Planning Board – Monday, June 24, 2019, 6:30PM
City Hall Council Chambers – 3 Washington Street, 2nd floor

SPR-972 MODIFICATION 3 – 222 WEST ST – COLONY MILL MODIFICATIONS

SUBJECT: Comments on Site Plan Application (SPR 972 Mod. 3) for 222 West Street, Colony Mill

SITE PLAN APPLICATION REVIEW COMMENTS

UP DOWN LIGHT PICTURE

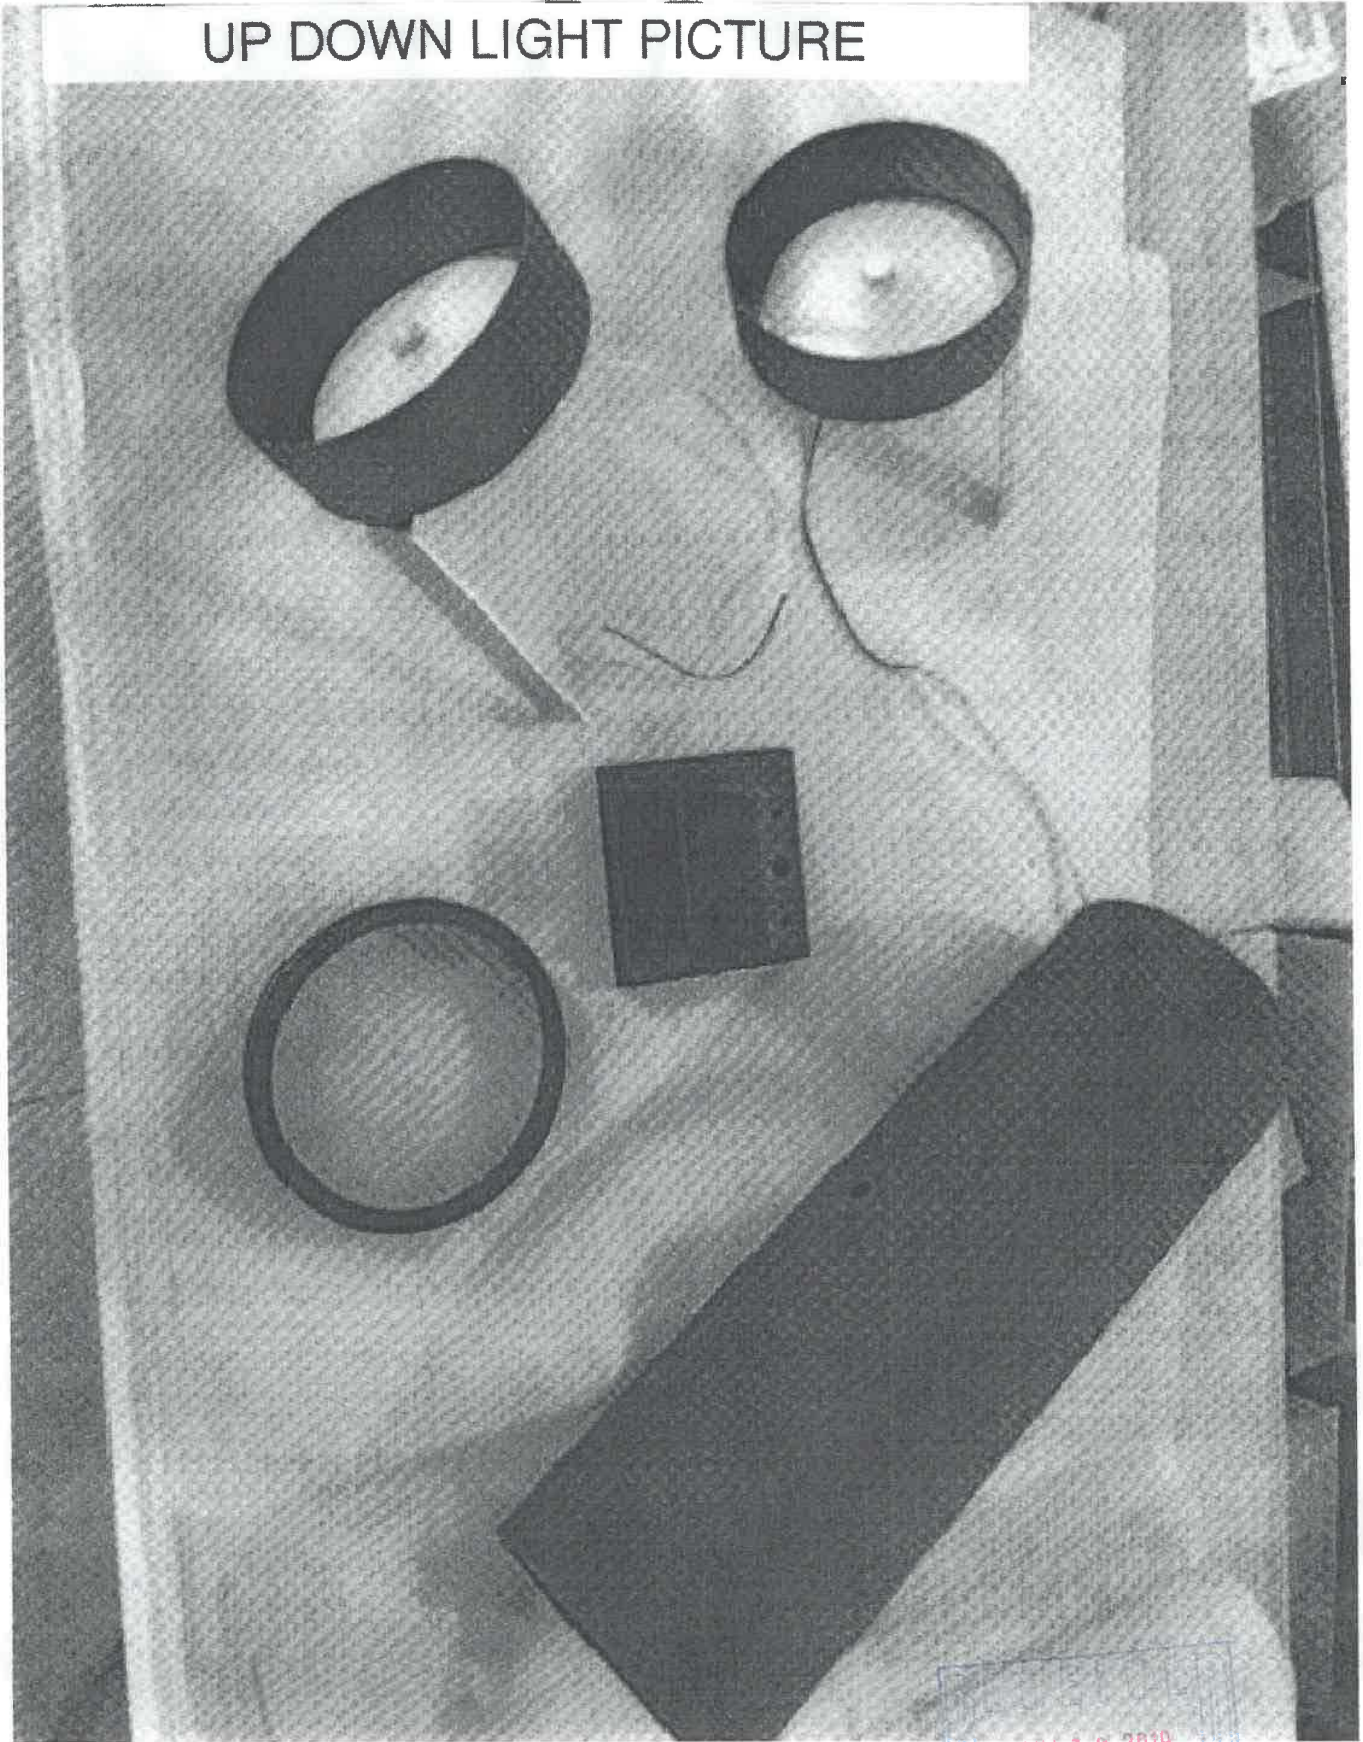
- a) The lighting fixture selected for the proposed wall mounted lights is an uplight/downlight. Per section 10.C.1 of the Planning Board Development Standards, uplighting is prohibited. This fixture does not meet the Planning Board's Development Standards.

CONDENSER ATTACHMENT

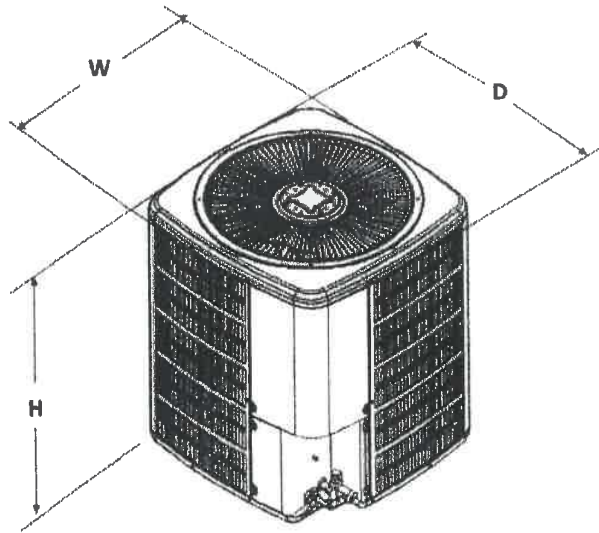
5. Condensers:
- a) The proposed condensers will be located in a visually prominent location. Is it possible to relocate these condensers to an area that is not visible from the public right of way? If not, please describe why this is not feasible. If it is feasible, please submit a revised plan showing these condenser units in a less visible location.

- b. See new Plan – Page SK-2.2
- 5. Condensers:
 - a. The condensers are limited to how far they can go due to their line set lengths. The limit for these line sets is a maximum of 79'. See Line Set Attachment. Including pictures of Mill prior to construction showing condensers and exhaust fans on exterior of building.

DUMPSTER SCREEN PICTURE

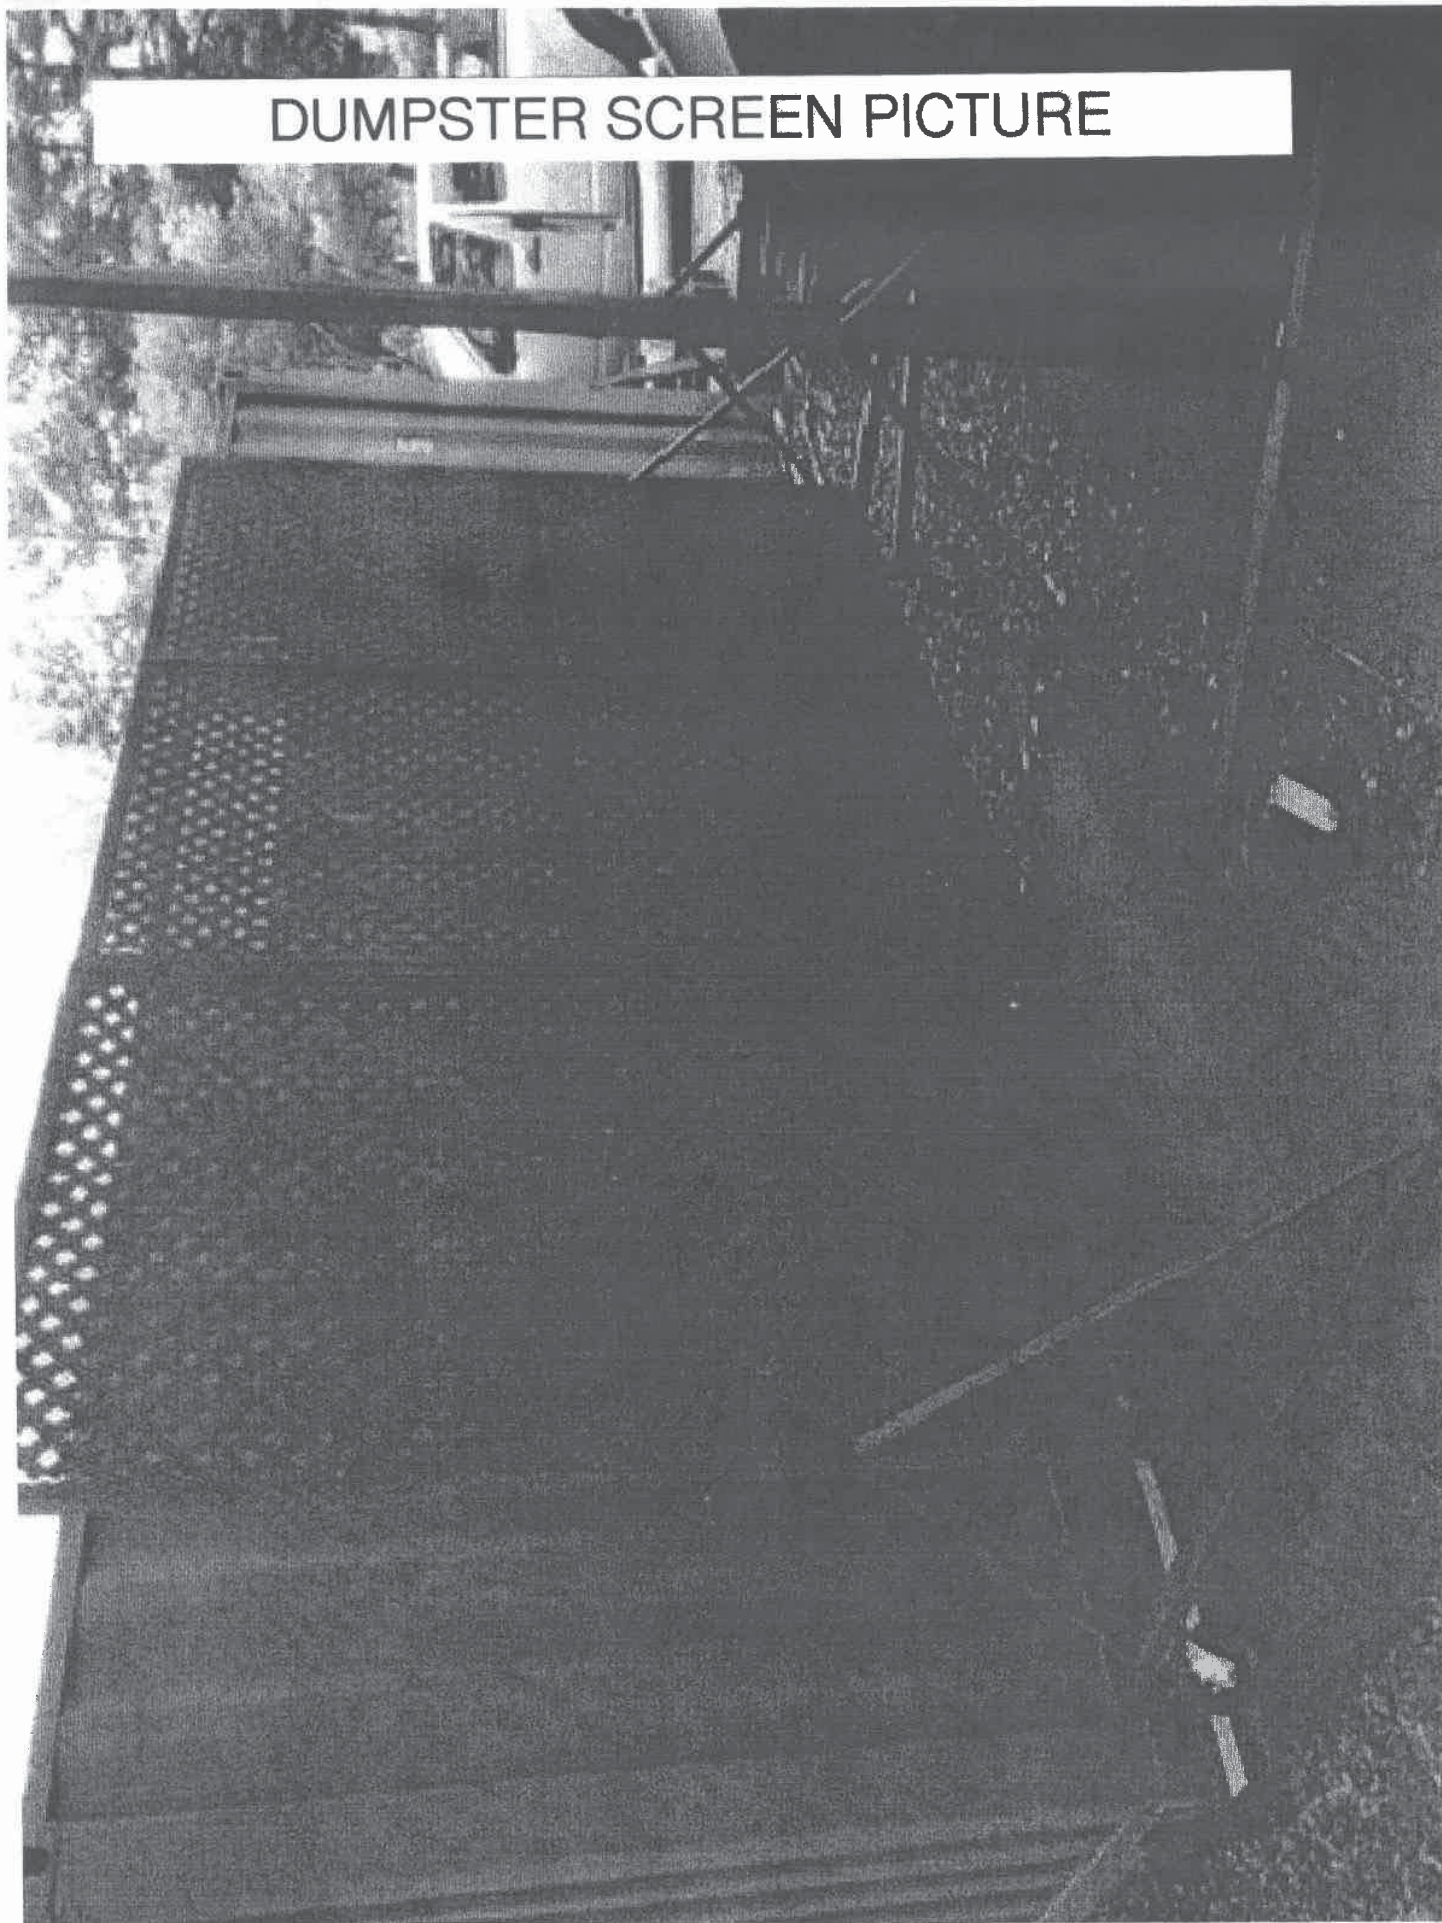
6. Dumpsters:
- a) The plans show two large dumpsters at the south side of the building. These plans do not show how these dumpsters are screened from view. Please describe how these dumpsters will be screened and enclosed and submit drawings/details illustrating the proposed enclosure. Section 8.a. of the Development Standards describes the screening requirements for dumpsters.

A2-3

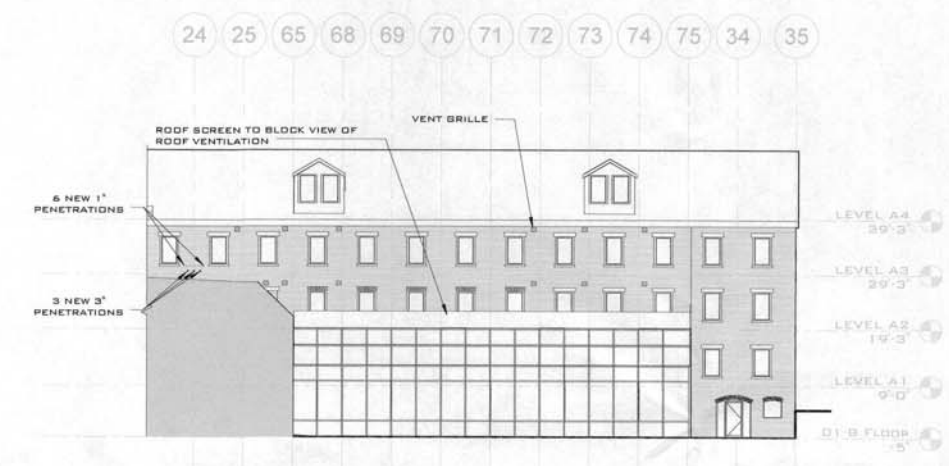
- **Roof Mounted Vents:** The Applicant is also proposing to install 11 low profile vents on the roof of the glass atrium. These vents would need to be installed on a 12” high curb mounted to the roof of the atrium. The specifications for this vent are included in the meeting packet. Each of the low profile vents would be 11” wide by 6.5” tall by 13” long. To screen these vents from view, the Applicant is proposing to install a 30” roof screen. This screen is depicted on the Sheet A2-3 of the elevations submitted for this application.

4. Exterior Ventilation:
- a) Please submit a sample and manufacturer's specifications for the vent cap that will cover the proposed exterior penetrations for ventilation. These specifications should show the color, finish type, and size of the proposed vent cap.

4. Exterior Ventilation:
 - a. Please see External Grill attachment for specifications of proposed vertical wall vent and the Low Profile Roof attachment for specifications of proposed roof vents on atrium. Both come aluminum, but plan to paint to match brick with Sherwin Williams color #2803 Rookwood Terra Cotta. The low profile roof vents would have to be on a 12" curb. We are also proposing a 30" roof screen on atrium to help minimize the visual impact of these low profile roof vents. The roof screen is on plan page A2-3.
